Loreto School

Concept Proposal and Stage 1 Development Application

Response to Submissions – SSD 7919

Part 1 - Response to Agency Submissions

Figure 1 – Summary of design amendments made following community consultation

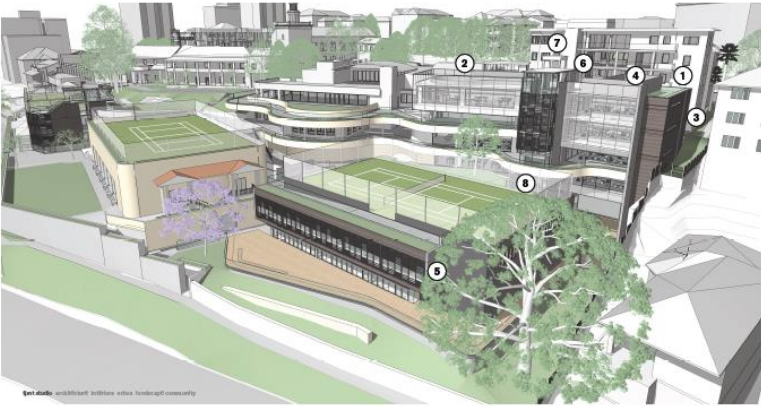
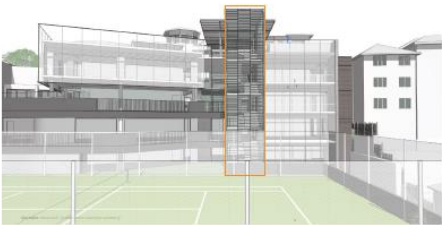
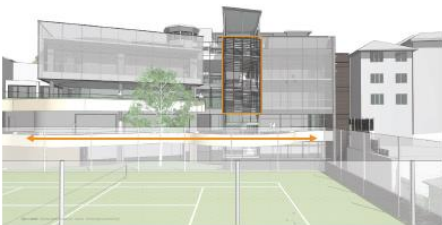
<p>The EIS does not include details of the use of the roof terrace located above the learning hub on the western precinct. An assessment of the acoustic impacts related to such usable has also not be undertaken.</p>	<p>The original intent of the roof top terrace was to provide a landscaped outdoor learning area and horizontal connection between the Learning Hub and adjacent Marian Centre Building. This was in alignment with the project specific design principles and Principle 1 of the Education SEPP. Following the community consultation, design</p>

Issues Raised by Agencies and Organisations	Proponent's Response
	<p>and operational changes were investigated to improve the visual amenity and acoustic impacts of the rooftop terrace for the adjacent neighbours.</p> <p>In order to reduce the acoustic impact, address privacy concerns and improve the outlook for the adjacent neighbours, the outdoor learning area was removed and replaced by an extended roof garden. The intended use of the rooftop terrace has been limited to enable connectivity between the Learning Hub and the Marian Centre and to allow intermittent staff and student access to the rooftop garden for maintenance. The roof garden may occasionally be used as a supervised recreation space.</p> <p>Further to the above changes, the plant equipment was reduced in size and redistributed to alternative locations, maximising the area of the roof garden. The remaining plant equipment was relocated to the least visible location when viewed from 111 Carabella Street.</p> <p>The circulation path providing the connection between the two buildings has been set back as far as possible from the boundary (15.5m) and a planter has been integrated into the western facade to provide a landscaped buffer between the adjoining properties. Improving accessibility and way finding, and the integration of the landscape, are key components to the identified design principles of the Masterplan. The above amendments have enabled the achievement of these principles whilst minimising the acoustic impacts and improving the outlook for the adjacent residents.</p>

Issues Raised by Agencies and Organisations		Proponent's Response	
Original Community Consultation Scheme		SSD Revised Scheme	
		Summary of Changes <ul style="list-style-type: none">1 Parapet reduced in height and introduction of an integrated planter creating a landscaped buffer to 111 Carabella Street.2 Increased roof garden3 Western boundary facade articulation; through high level windows and brick detailing4 Relocated and reduced footprint of mechanical plant - Acoustically treated5 Building setback to improve access to light and air - 22 Elamang6 Louvred roof removed7 Glazed Lift8 Reduced bulk and scale of connector form

Figure 2 – Summary of design amendments made to the western façade of the Learning Hub following community consultation

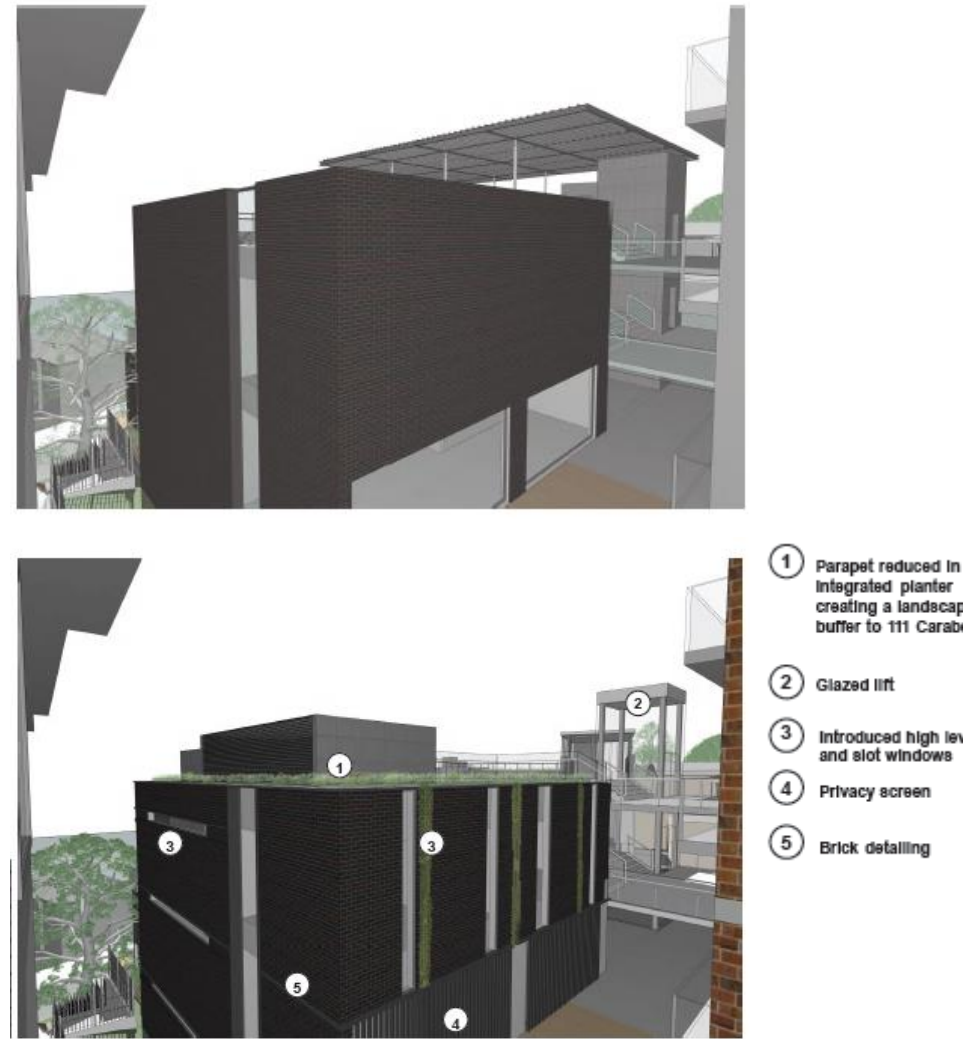
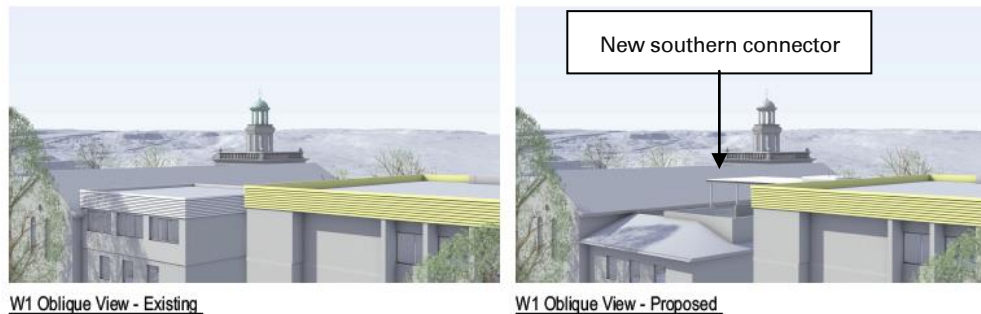
<p><i>Privacy (Visual and Acoustic)</i></p> <ul style="list-style-type: none"> Privacy concerns are raised regarding the lower levels of the new Learning Hub at the western end of the site and the view and noise corridor created as a result of the orientation of and depth below ground level of the lower levels of the hub towards the existing residential flat building at 22 Elamang Avenue, Kirribilli. Additionally, the new Learning Hub building proposes a new rooftop activity area. Any use of this area should be restricted to ensure there are no adverse noise or visual privacy impacts occurring from this new roof area. 	<p>The outdoor learning area associated with the lowest level of the new Learning Hub is set back from the boundary in accordance with the North Sydney Council DCP and is also further set back due to the additional site which lies between 22 Elamang and Loreto. As this area is excavated below the level of the adjacent boundary, visibility is either not possible (from the lower apartment) or oblique (from the upper levels).</p> <p>Refer to responses above. A number of changes have been made to the design and operation of the roof top terrace following the community consultation process. The roof top will now be used as an extended roof garden. Access to the rooftop terrace will be limited to enable connectivity between the Learning Hub and the Marian Centre and to allow intermittent staff and student access to the rooftop garden for maintenance. The roof garden may occasionally be used as a supervised recreation space.</p> <p>In addition, the circulation path which provides the connection between the buildings has been set back as much as possible from the boundary (15.5m) and a planter has</p>

Issues Raised by Agencies and Organisations	Proponent's Response
 <p>The image shows two architectural renderings of the western facade of the Learning Hub. The top rendering shows a side view of the building with a dark, textured facade. The bottom rendering shows a front view of the building with several callouts (1-5) indicating design amendments. Callout 1 points to the roofline, callout 2 points to a glazed lift, callout 3 points to high level windows and slot windows, callout 4 points to a privacy screen, and callout 5 points to brick detailing.</p>	<ul style="list-style-type: none">1 Parapet reduced in height integrated planter creating a landscape buffer to 111 Carabella St2 Glazed lift3 Introduced high level windows and slot windows4 Privacy screen5 Brick detailing

Figure 4 – Plan of Lower Ground Level 4 showing proposed end of trip facilities

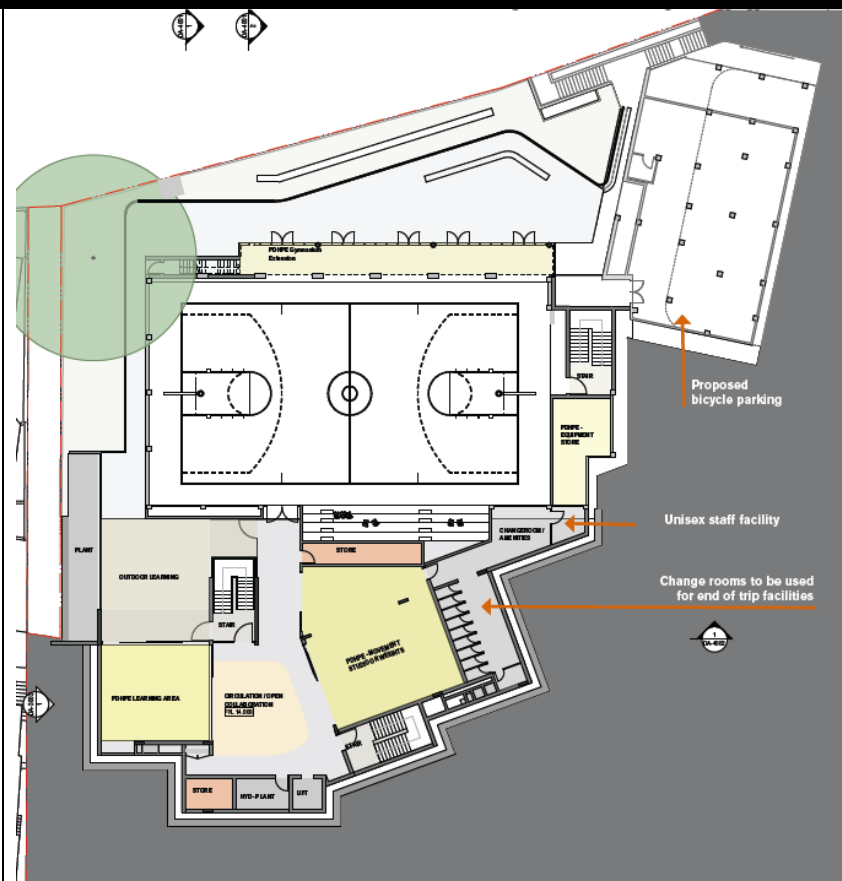
<p>The Stage 1 works should accommodate bicycle parking provisions within the site to encourage alternate modes of transport.</p>	<p>End of trip facilities are provided at Lower Ground Level 4 of the new Learning Hub (refer to Figure 4).</p> <p>Bicycle parking spaces are able to be provided in the existing sports storage area on the Lower Ground Level of Centenary Hall, with the end of trip facilities within the adjacent Learning Hub. Access is able to be provided directly off Elamang Avenue via a stair ramp on the existing stairs.</p>

Figure 5 – Relationship between 111 Carabella Street and the proposed Learning Hub

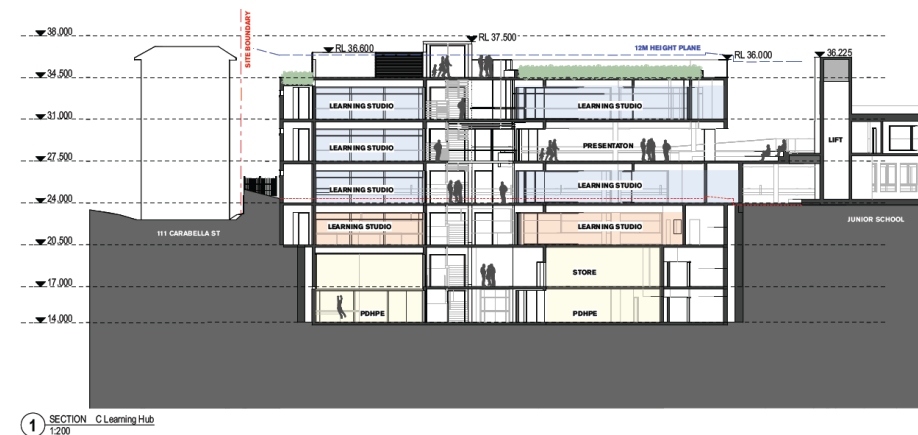
- North Sydney Council is of the view that the scale of the New Buildings particularly the new additions to the western building (Learning hub) located close to the adjoining boundary site are incompatible with the site's adjoining and opposite along Carabella Street and Elamang Avenue. Existing buildings at the eastern end of the sites are zoned R2 Low Density Residential with a maximum permissible building heights of 8.5 m.

The proposed Learning Hub has been designed to use the topography of the site in order to minimise its apparent height. The Learning Hub is entirely consistent with the surrounding built form for the following reasons:

- It is only two storeys above street level (Carabella Street) and is lower than the existing Marian Centre when viewed from Carabella Street.
- The Learning Hub is well within the height of the School Chapel, which sits at approximately 24.7m.
- The land immediately to the west of the campus (at the interface with the Learning Hub) is zoned R4 High Density Residential. The proposed Learning Hub is consistent with the scale of the apartment building immediately to the west at 111 Carabella Street (refer to the Section at **Figure 5**).

Figure 9 – Oblique (worst case) and total views from W22

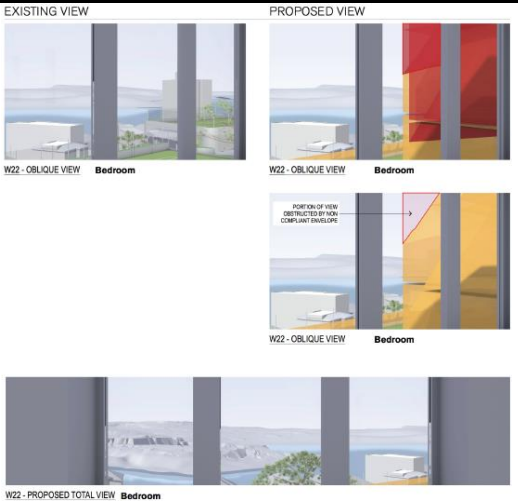
<p>The EIS suggests that apartments orientated towards the north-east with unencumbered views towards the Harbour and Kurraba Point will remain largely unaffected by the proposal. That statement is only true if losing up to 50% of existing views means "largely unaffected". However, it is considered that an unbiased opinion would not categorise a 50% loss as largely unaffected. Refer to Pictures and Figures below for more details.</p>	<p>FJMT has prepared a response to the letter prepared by Tranplan (refer to Appendix C).</p> <p>In regard to the views from the north facing apartments (views W21, W22 and W23), view impacts from these apartments were tested from a number of angles to assess the overall view loss. Refer to the Figures 8 – 10 and attached drawing sheets SKMP-60.1/SKMP-60.2 (Appendix C) for further details.</p> <p>Figure 8 shows view W21, taken from a worst case view point looking obliquely across the school site. However, when looking directly out of the window (the total view) there is no impact to the existing views. The same applies to W22 and W23 (Figures 9 and 10) which show that the proposal will have no, or minimal, impact on total views.</p> <p>As illustrated below, the loss of views as a result of the non-compliance (shown in red) is considered to be relatively minor when considering both the total view and the oblique</p>

Issues Raised by the Public	Proponent's Response
	<p>view - W21 shows a small portion of harbour view loss and W22 shows small portion of sky loss from the non-compliant envelope. From W23, the non-compliant envelope does not result in any additional view loss. It is important to note that the non-compliance relates to the DCP, rather than the LEP. As detailed above, SSD applications are not required to comply with the provisions of a DCP.</p> <p>Overall, it is considered that the view loss from these apartments (when the total views are considered) are minor and acceptable, and are generally associated a complying built form. Direct views from these dwellings to the north across the front boundary will remain unaffected by the proposed development.</p> <div data-bbox="1108 671 1601 1157"><div><div>EXISTING VIEW</div><div>W21 - OBLIQUE VIEW Bedroom</div></div><div><div>PROPOSED VIEW</div><div>W21 - OBLIQUE VIEW Bedroom</div></div><div><div>W21 - OBLIQUE VIEW Bedroom</div></div><div><div>W21 - TOTAL PROPOSED VIEW Bedroom</div></div></div> <p>Figure 8 – Oblique (worst case) and total views from W21</p>
